REQUEST FOR INFORMATION	DATE: March 28, 2017	NO.: RFI-497
--------------------------------	-----------------------------	---------------------

Project Name:	15051-Webster University Interdisciplinary Science Building	Project No.: 15051
---------------	---	--------------------

Subject: Proposed detail for screen wall door

PLAN DETAIL @ Mech. screen Access gate:

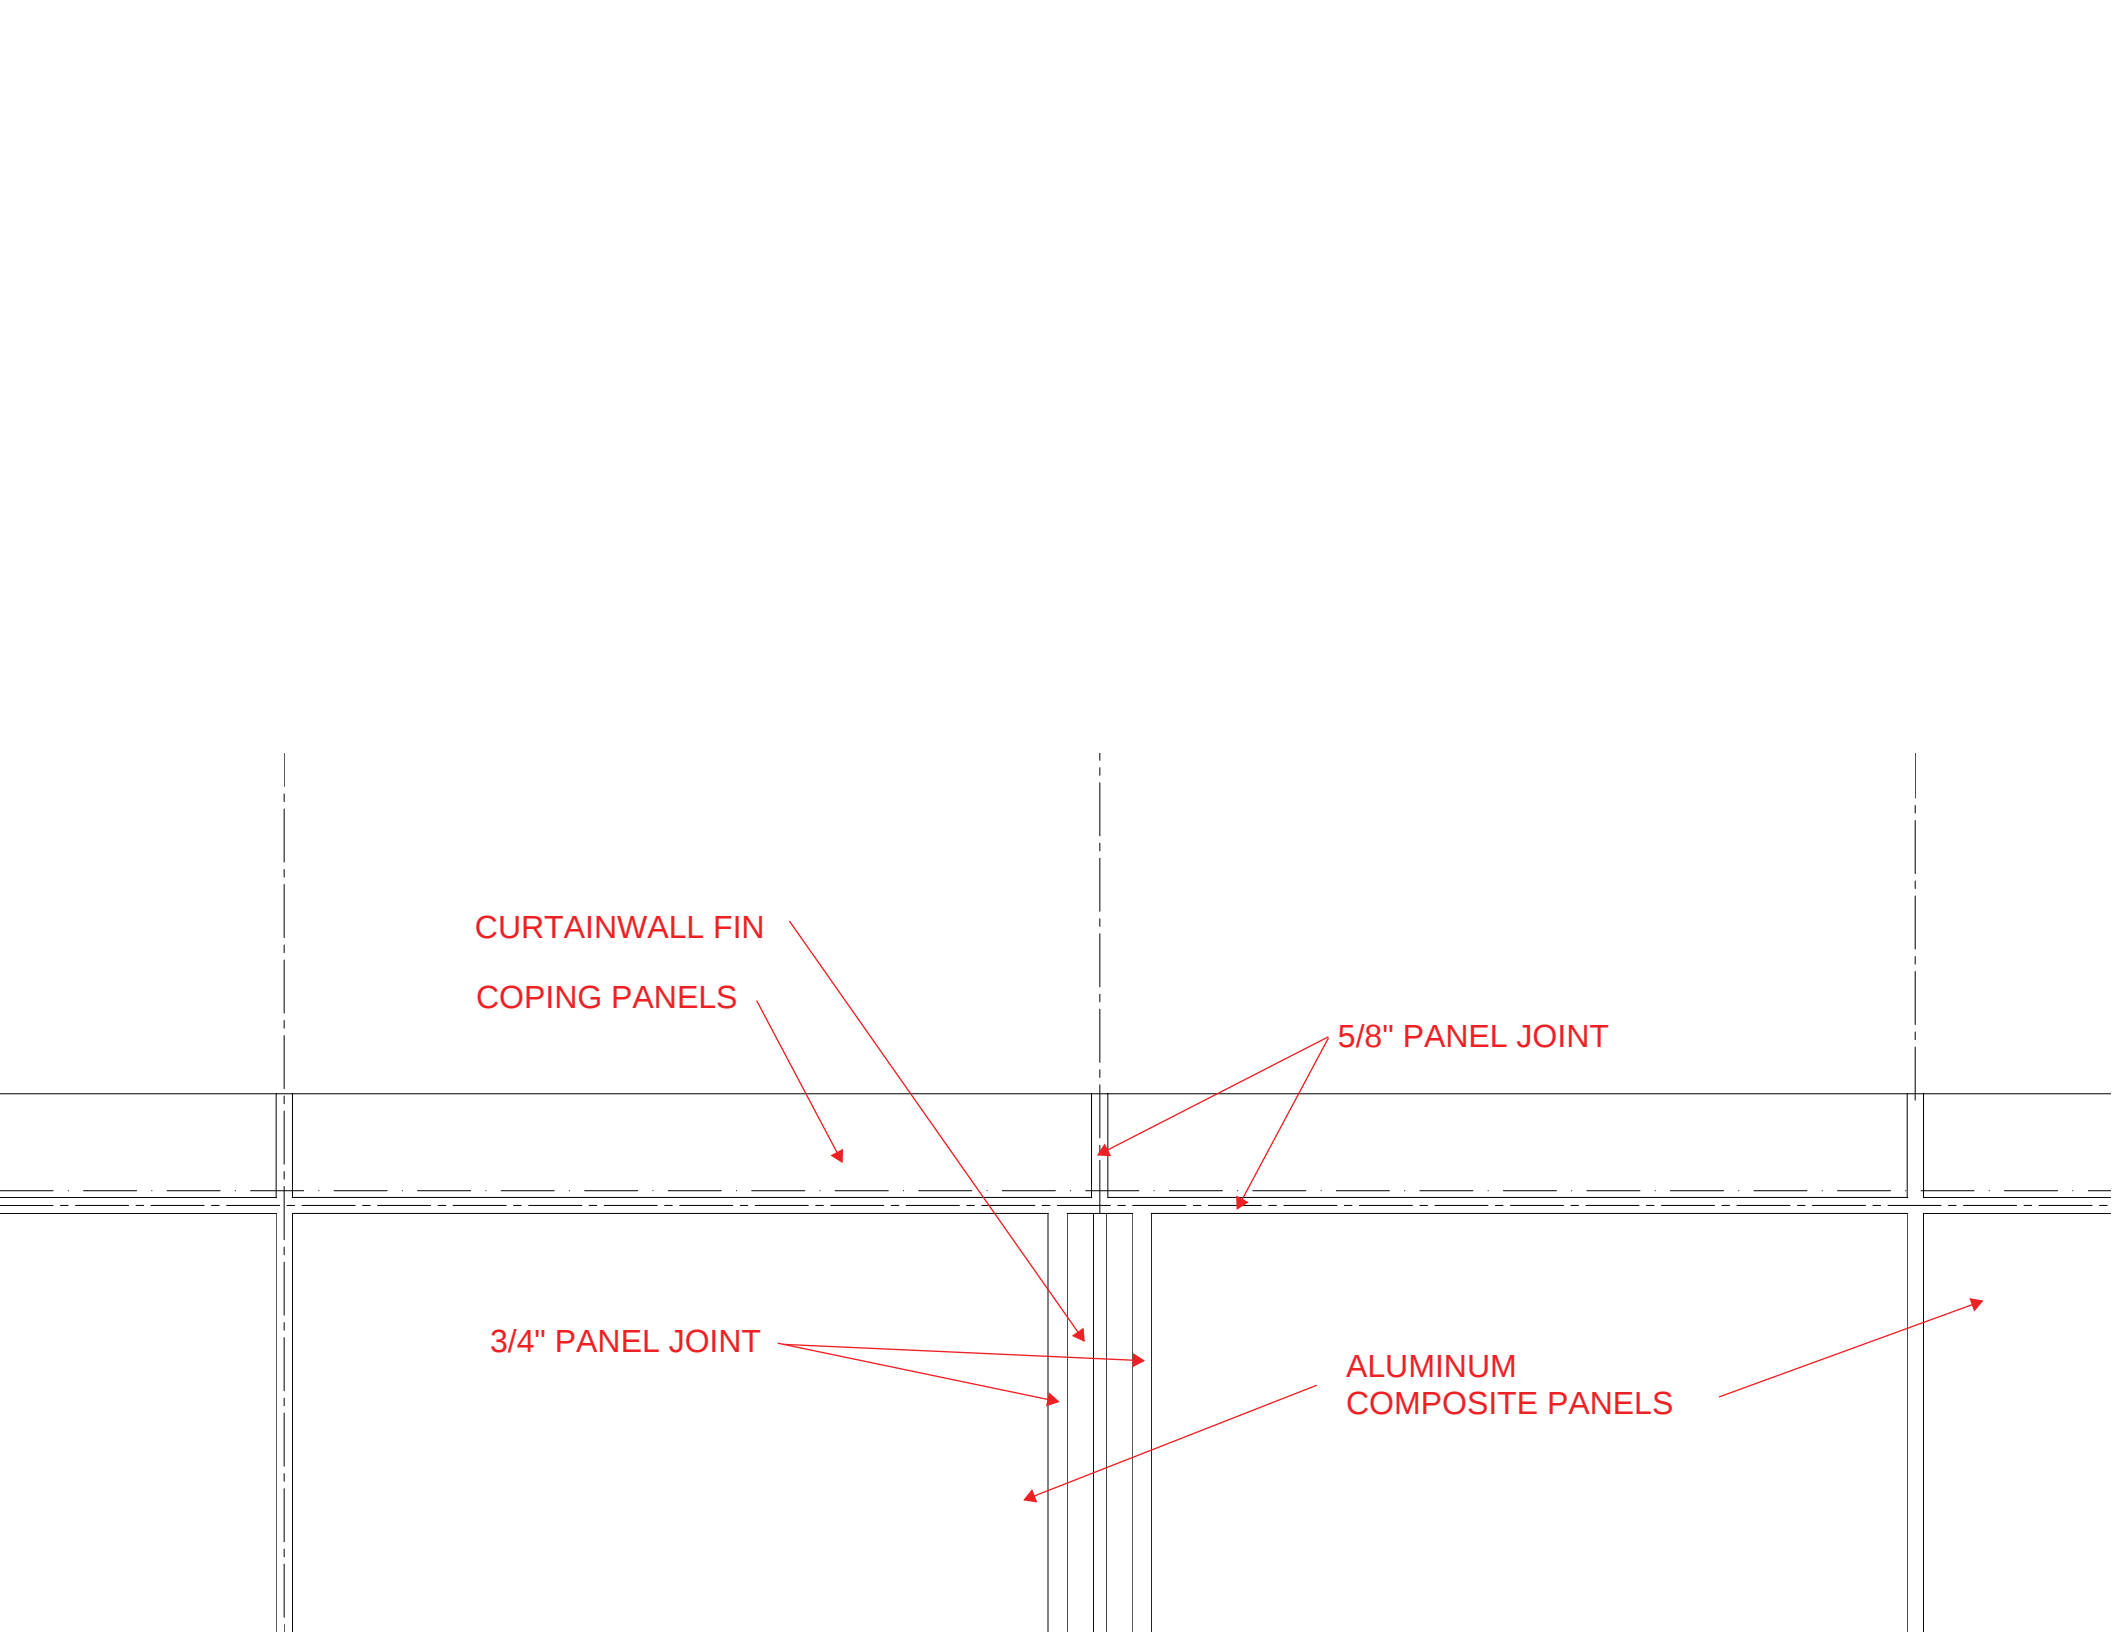
See attached proposed detail for screen wall door from Universe. Please advise if this will be acceptable.

Response: Door latch will need to be opened from both sides of door. Piano hinge shall be heavy duty stainless steel continuous hinge. Frame needs to be strong enough to resist racking and deforming from wind forces. Door will require a stay to keep it from opening into the panels behind.
Coping details are acceptable.
